Project Title: Redlands Passenger Rail Project (RPRP)

## Addendum No. 5 to the EIR

San Bernardino County Transportation Authority |  
Redlands Passenger Rail Project

November 2017

Figure 2: Foundation Design at Bridge 9.4 (Vertical)

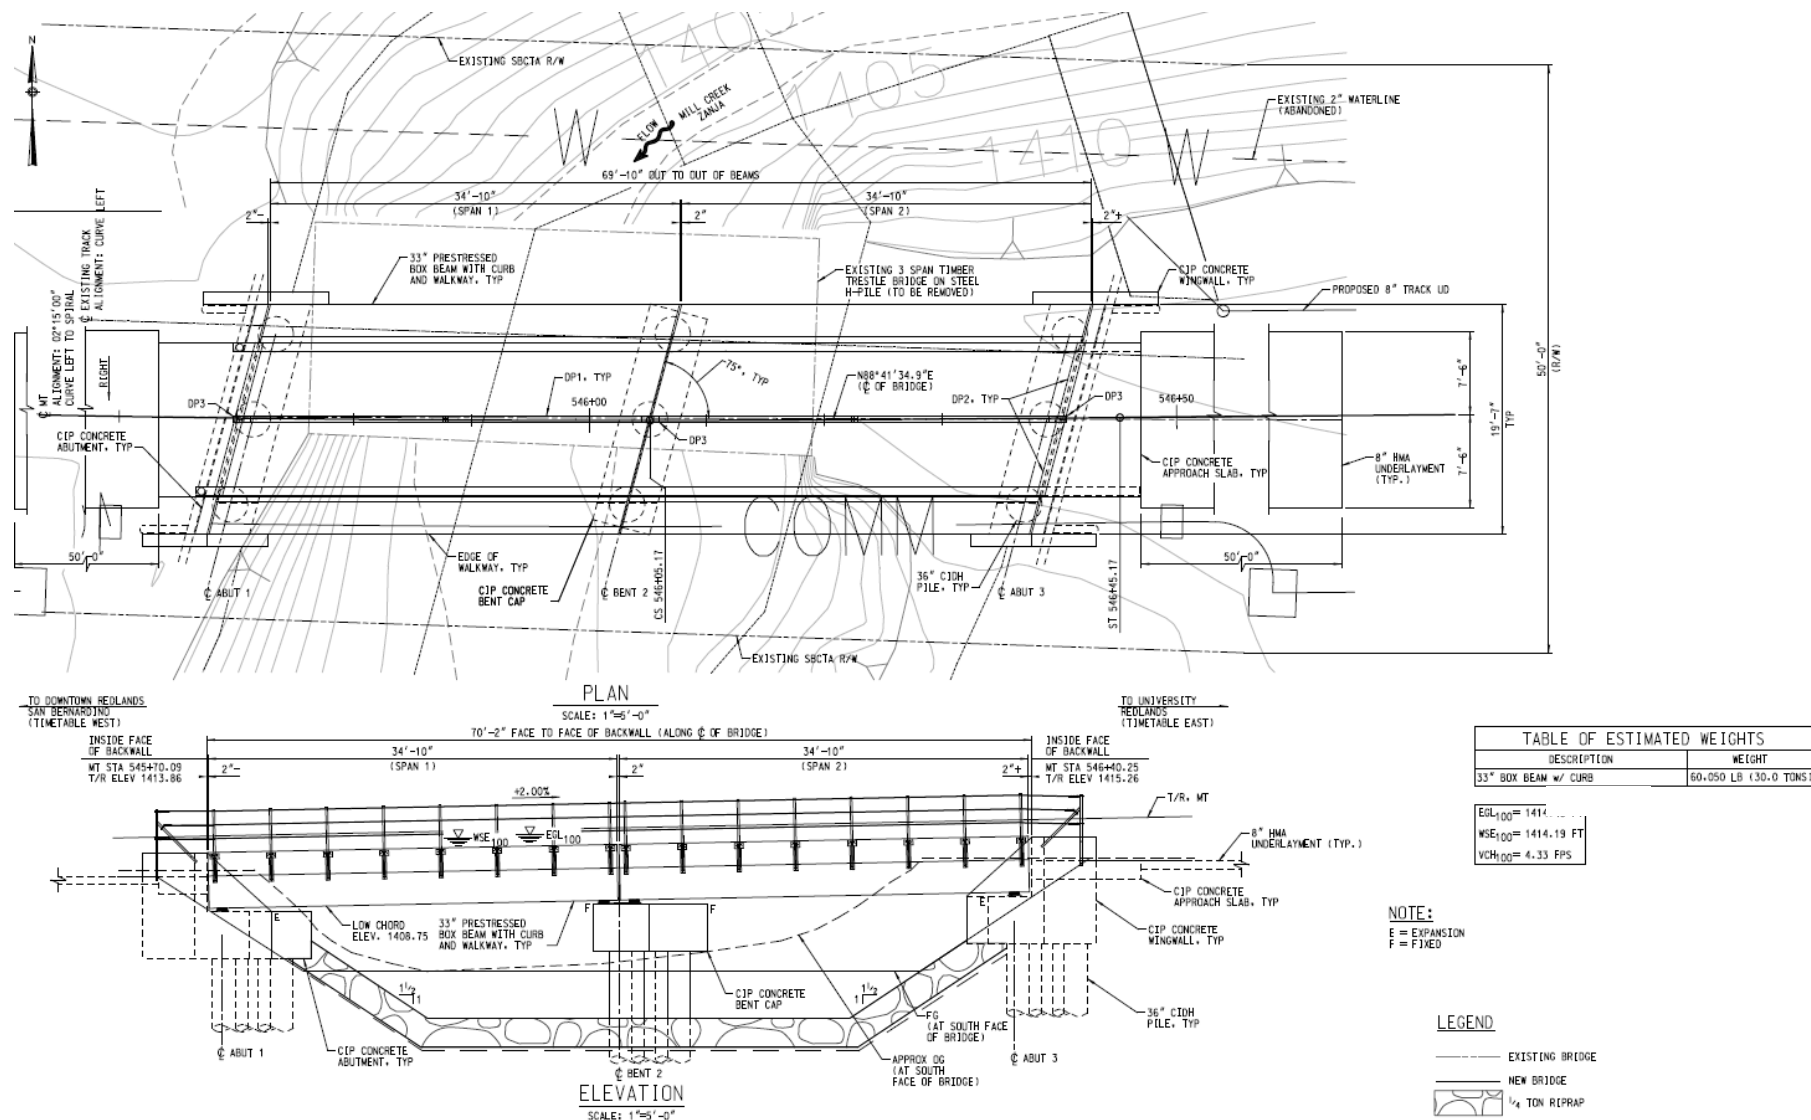
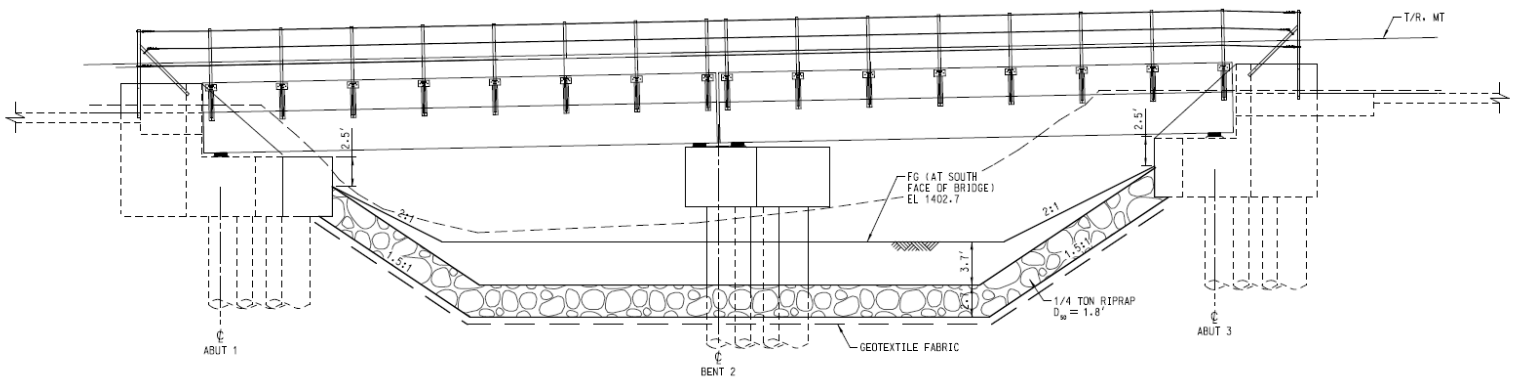
- a) *Design Refinements to Bridge 9.4:* Following additional hydrologic/hydraulic (H&H) modeling and geotechnical investigation as part of the approved Project's final design, SBCTA has refined the design for Bridge 9.4. These refinements include shifting the abutment angles such that they are positioned with the natural flow of the creek (Figure 2 of Attachment A). Riprap would line the channel slopes and bed (Figure 3 of Attachment A). The riprap would be approximately 2.7 feet thick along the bed of the creek (and buried at depth), sloping on either side of the banks at a ratio of 1.5 to 1. This bank protection would be required north and south of the bridge abutments.

Figure 3: Bank Protection for Mill Creek Zanja

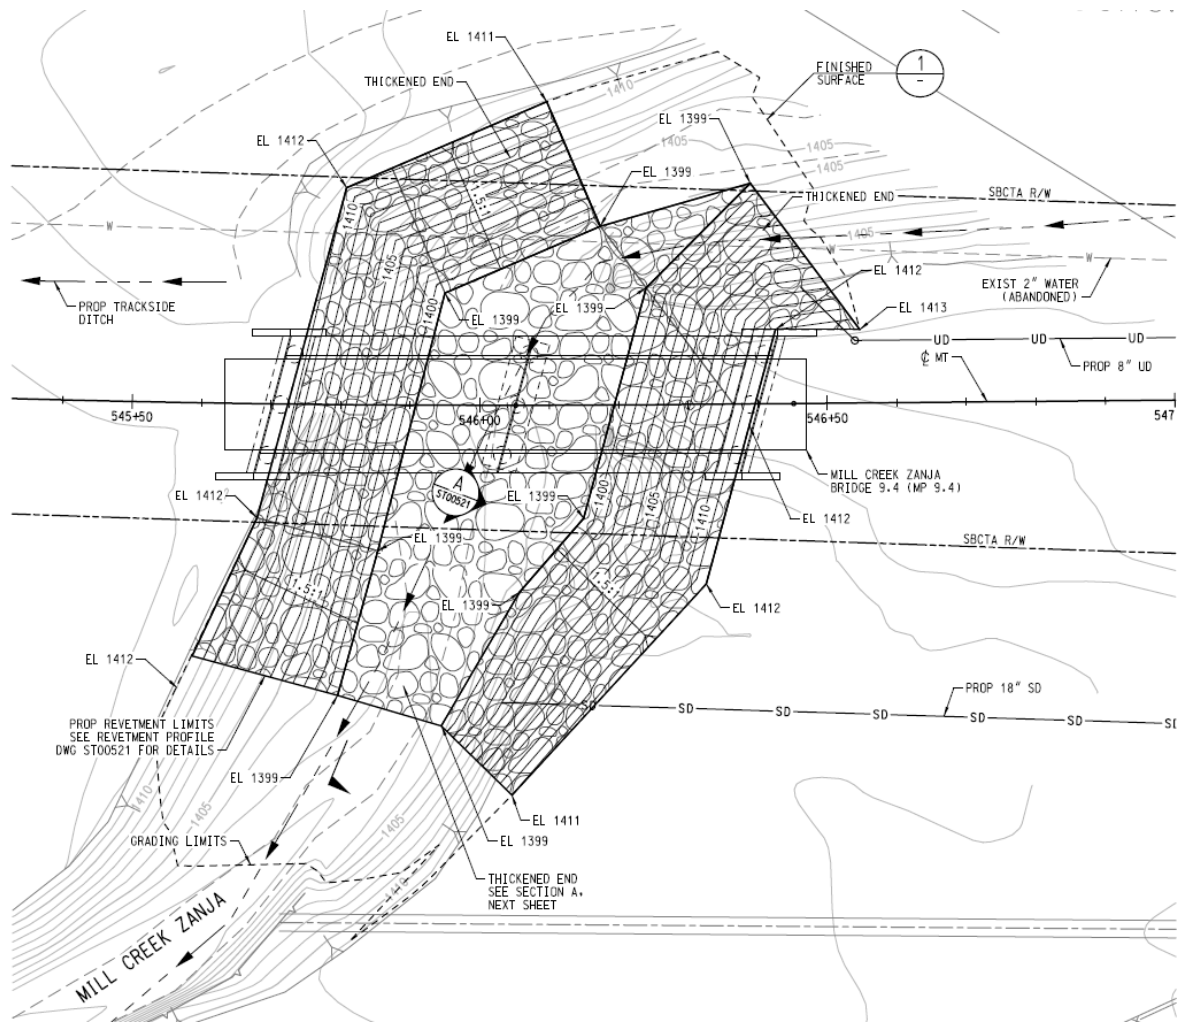
**Refinement No. 1 – Revised Structural and Drainage Design at Bridge 9.4 (Mill Creek Zanja):** SBCTA approved the construction of a single-track bridge<sup>2</sup> structure at milepost (MP) 9.4 as previously considered in the approved Project and Final EIR. SBCTA has identified additional refinements to the design for Bridge 9.4 to optimize the hydraulics in up- and downstream segments of the Mill Creek Zanja. These refinements include a relocated outfall and a new detention basin to the southeast of Bridge 9.4.

Figure 4: Proposed Detention Basin

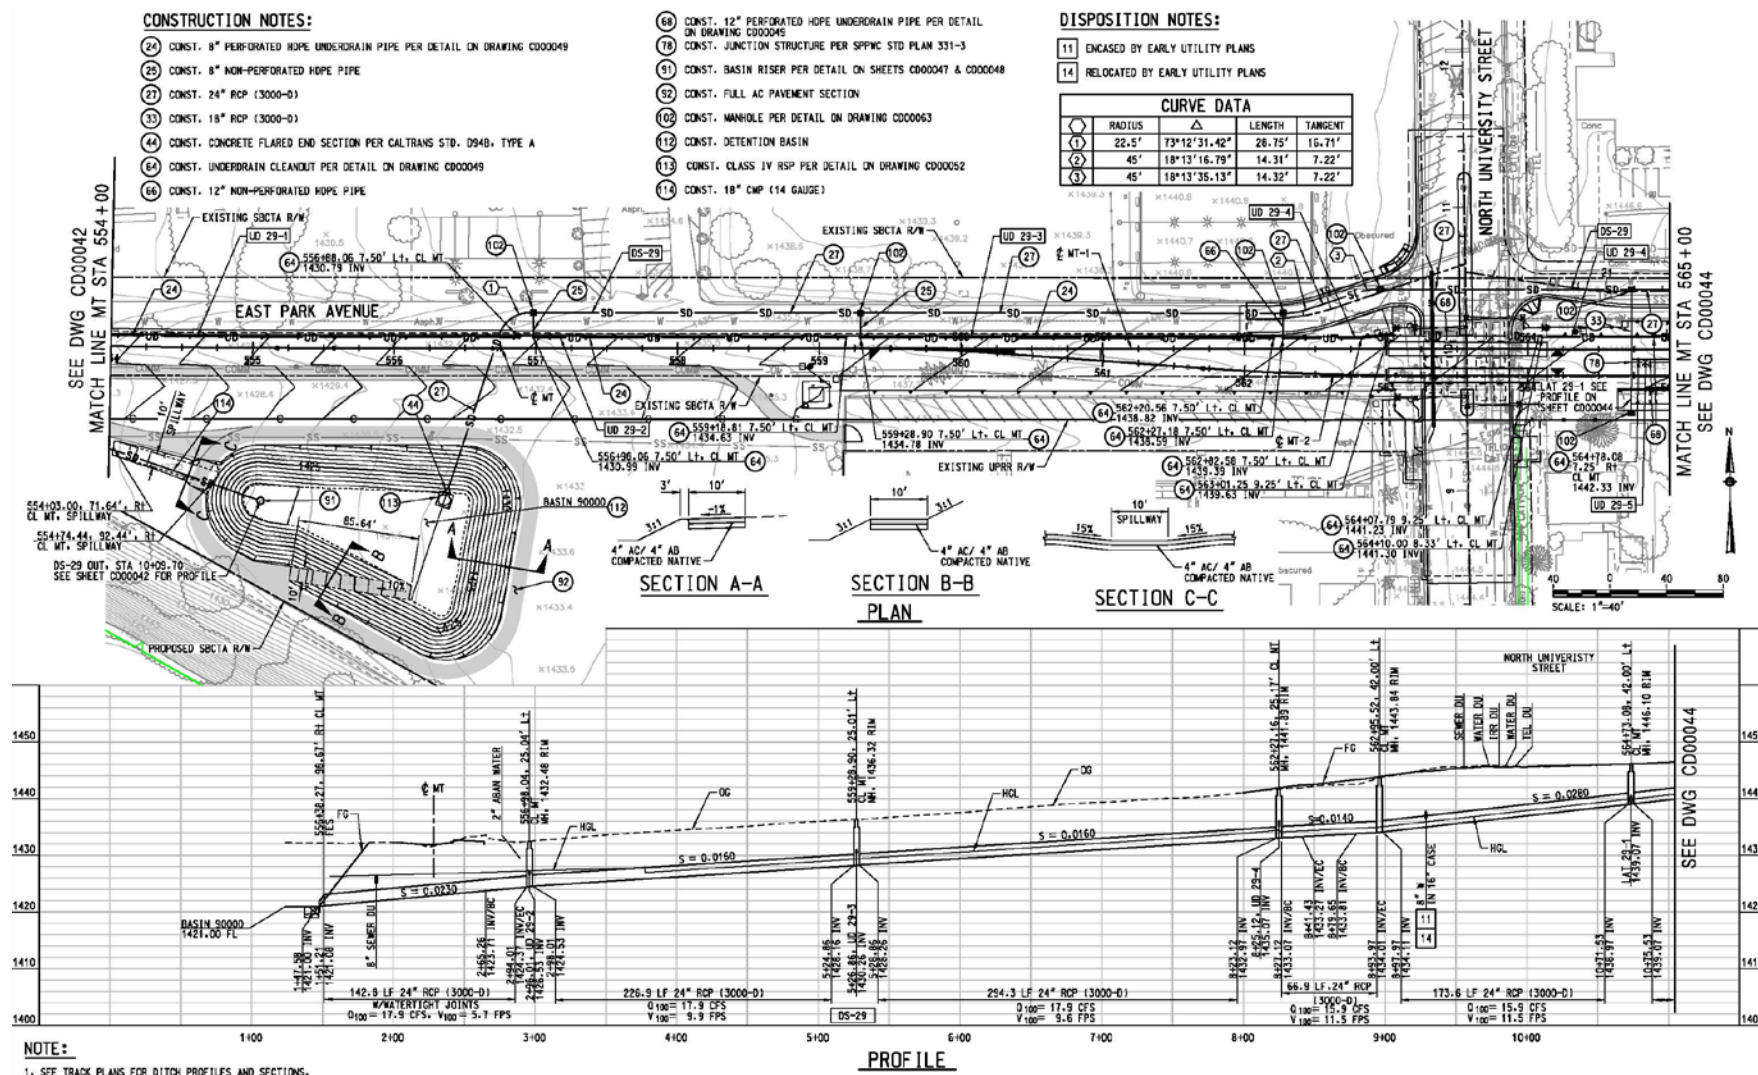
- c) *New Detention Basin:* Following additional drainage modeling as part of the approved Project's final design, SBCTA has identified a need for additional drainage capacity in areas east of Bridge 9.4. In response, a detention basin is proposed to the west of Bridge 9.4 on property owned by the City of Redlands (Figure 4 of Attachment A). The detention basin would be constructed on approximately 2.4 acres of land adjacent and to the south of SBCTA's railroad ROW (and east of I-10). Once constructed, the City of Redlands would own and maintain the detention basin.

Figure 5: Southeast Corner of Sylvan Park Changes

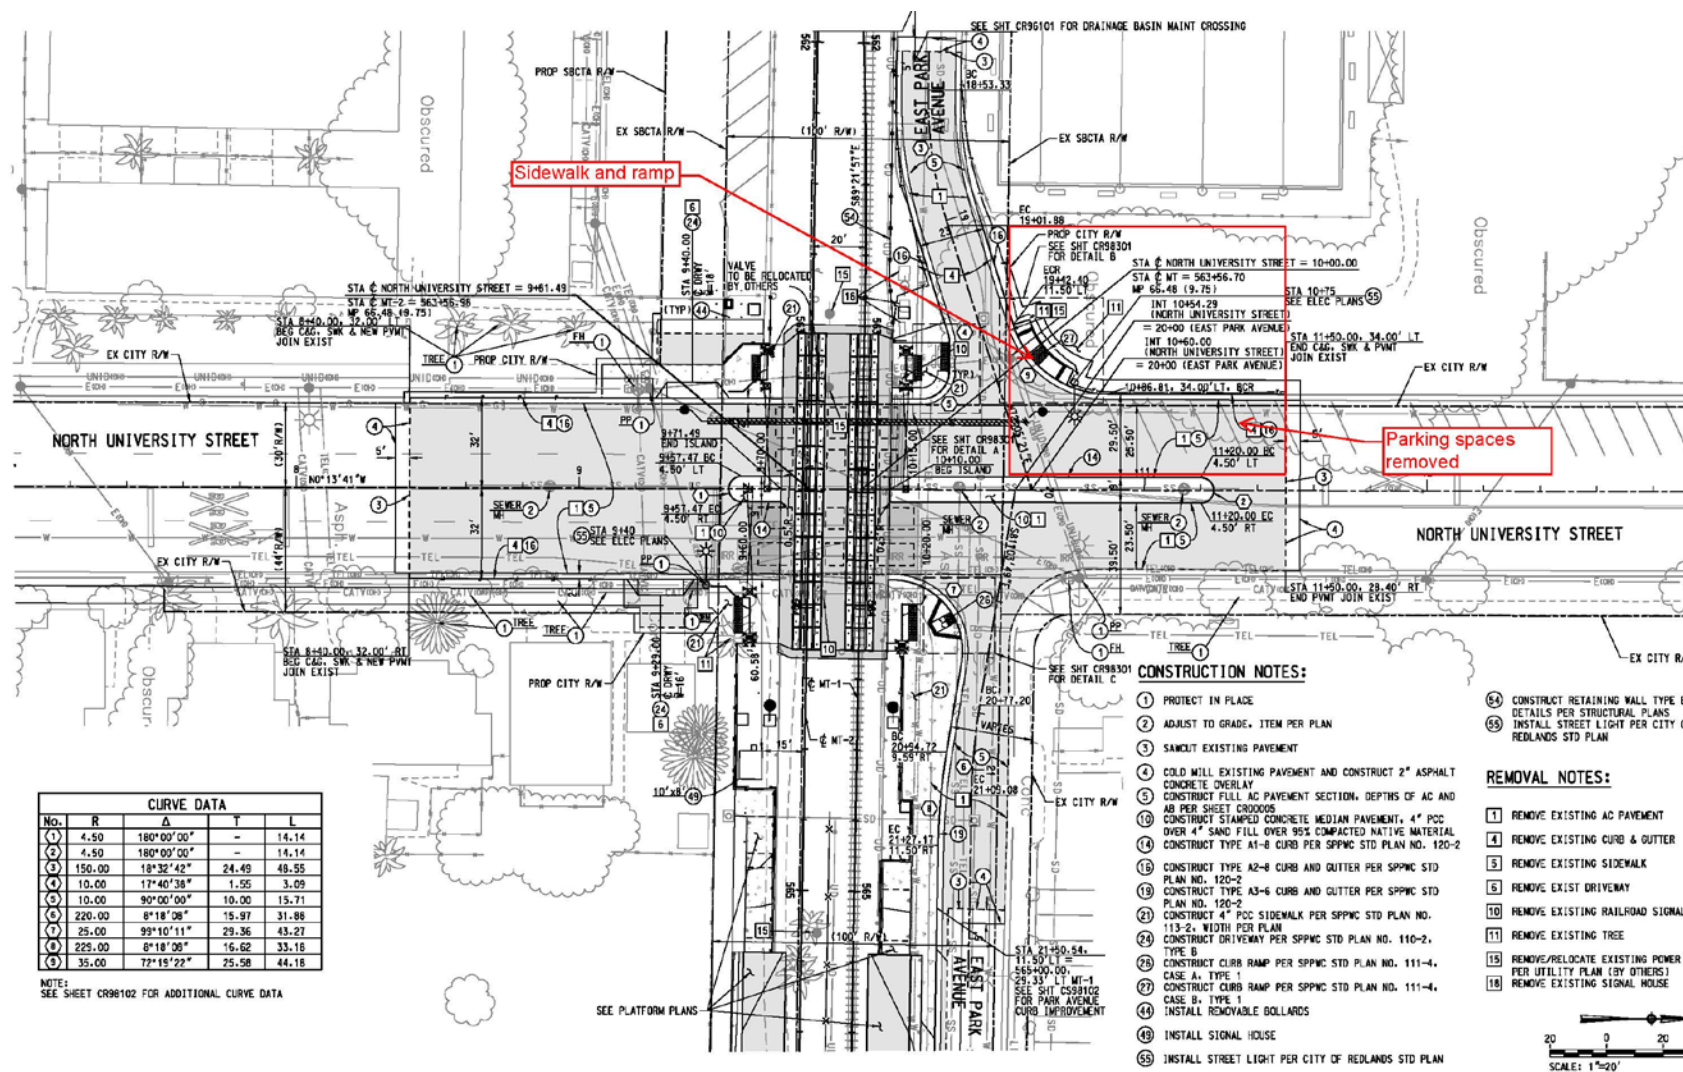
Project Description:
RPRP is an approximately nine mile corridor extending east from the City of San Bernardino to the City of Redlands, and includes local and express train service. SBCTA certified a Final EIR for the project in March of 2015. Following additional engineering during final design, SBCTA is proposing minor refinements to the project at Bridge 9.4 and University Street. These refinements include a revised design for Bridge 9.4, relocation of a drainage connection previously proposed at the Mill Creek Zanja, a new detention basin (east of I-10 and south of the railroad right-of-way), and expanded roadway improvements north of the at-grade crossing at University Street (and Park Avenue).
